Nov 4/97

FIELD AMENDMENT NOTICE

SNOW DETECTOR WIRING CORRECTION

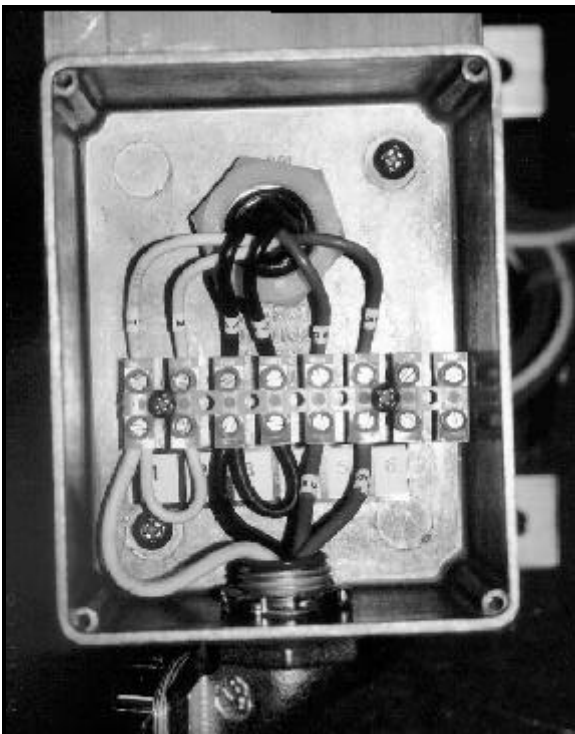
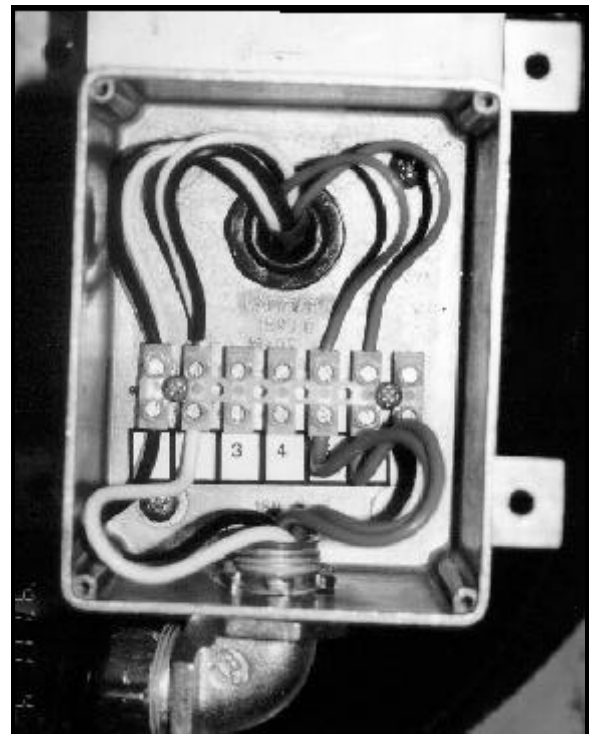
We have identified a snow detector cone and grid heater wiring error. Detectors with this error will not melt and detect snow.

Incorrect wiring

Correct the wiring by

- 1) Pairing a white from the cone heater with a black wire from the grid heater (wires 1 and 3) and place them into terminal 1. Take the remaining black and white wire pair (wire 2 and 4) and place them into terminal 2.
- 2) Remove the white jumper wire between terminal 1 and 2.
- 3) Remove the black jumper wire between terminal 3 and 4.
- 4) Connect the black and white leads from the conduit whip to terminals 1 and 2 respectively.

Remove junction box cover to access terminal strip. (Wiring shown is correct).

Correct wiring
